American Hakko Products, Inc.

PRODUCT BULLETIN

Bulletin No: PB523

Improvement to the housing for the ATX Series Drivers

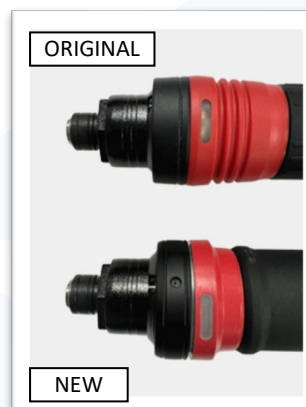
The housing of the ATX Series Drivers will now be made of aluminum featuring an ESD-Safe red powder coating. The thermoplastic rubber (TPR) grip area has been increased so the operator has a more comfortable hold of the driver, and the start lever is now a silver-plate resin for contrast with the grip. The LED work light skirt has been improved to strengthen the area around the transducer and housing, further enhancing the driver's accuracy and repeatability. Lastly, the reverse button on the driver is now recessed to reduce accidental activation when the driver is set down on a work surface.

Weight changed from 480g to 560g.
All other specifications are unchanged
